Subject: Teralba Quarry Project (10_0183)

**Lake Macquarie City Council comments on Environmental Assessment
Rhondda Road, Teralba**

3D Terrain Model

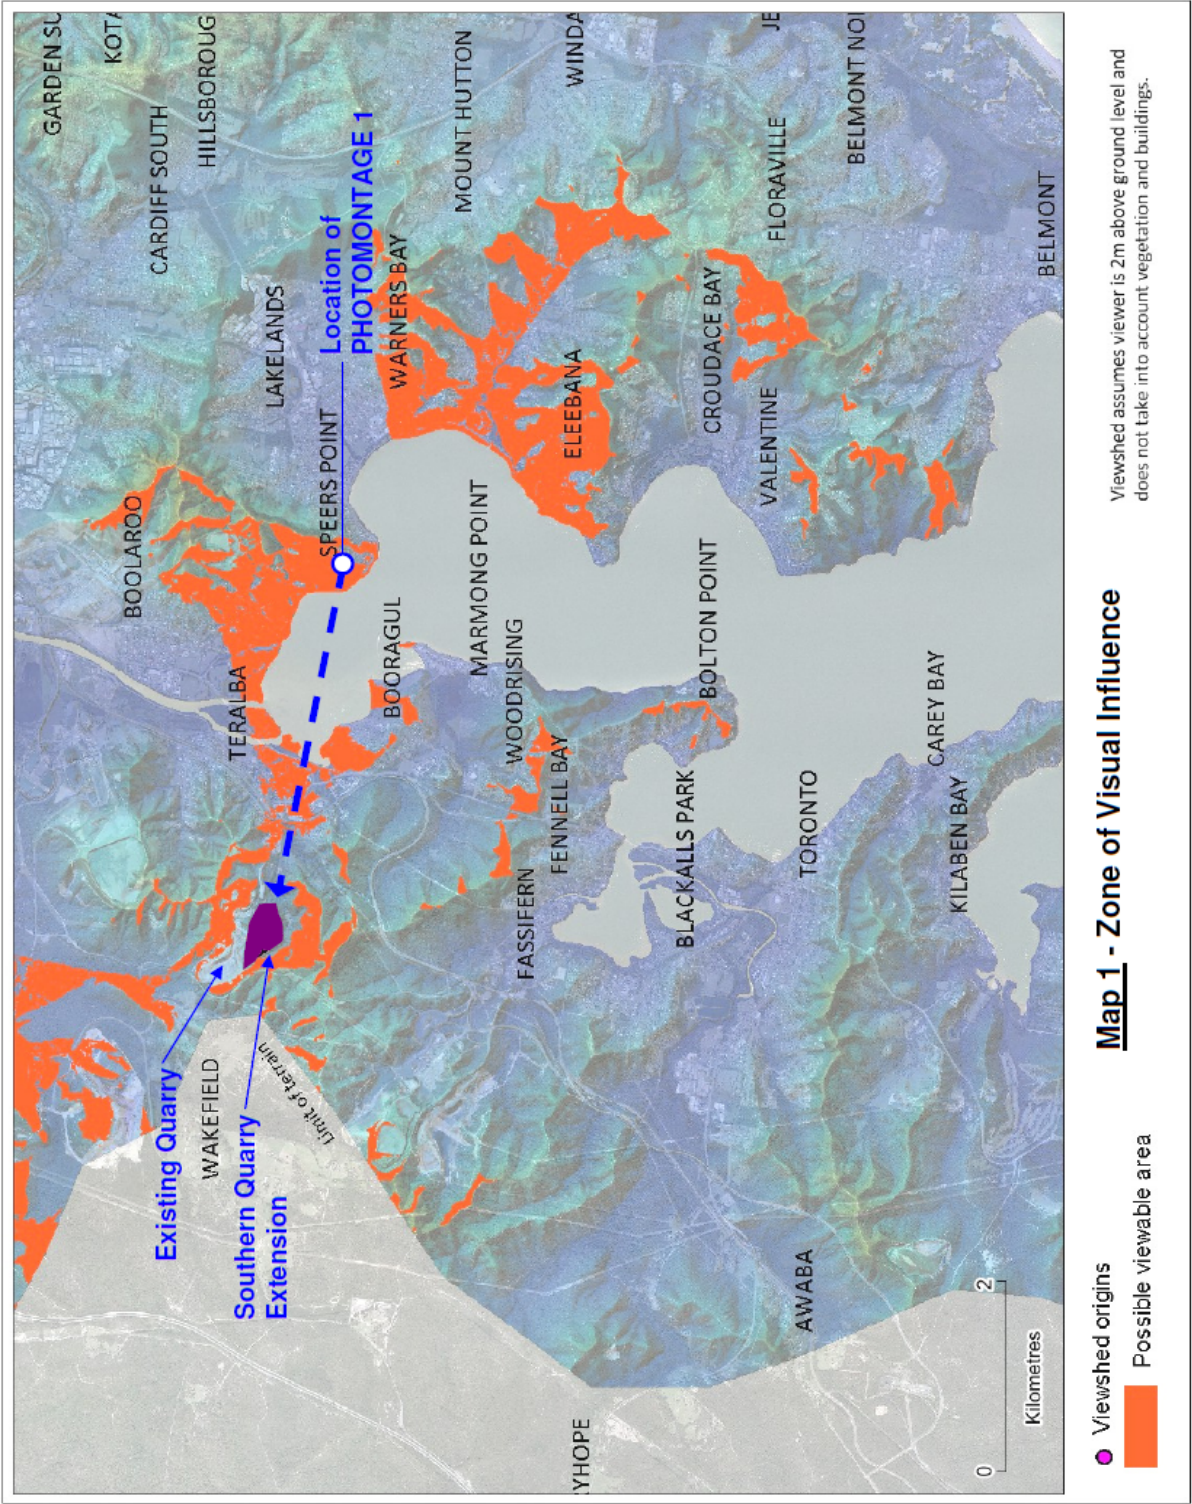
The proposal does not minimise earth works as part of productive use of the land. The proposal could potentially win material from the site in a visually sensitive manner by retaining the eastern portion of the south quarry extension. This would enable the natural ridgeline to visually screen the quarry.

Due to continued inadequacies associated with the (1) proposed transmission and distribution line relocation environmental assessment, and (2) visual impact assessment and mitigation measures, the proposal is inconsistent with the strategic planning framework.

- Engage a qualified landscape architect to conduct a detailed visual impact assessment of the proposal that includes photomontage modelling of the proposed impacts of the quarry with and without mitigation measures from key vantage points;
- Include in the visual assessment a scenario to retain the eastern portion of the south quarry extension to provide visual screening of the quarry with the natural ridgeline; and
- Re-exhibit the visual assessment to permit the community and stakeholders to provide comment on an accurate assessment of the visual impacts proposed by the southern quarry extension.
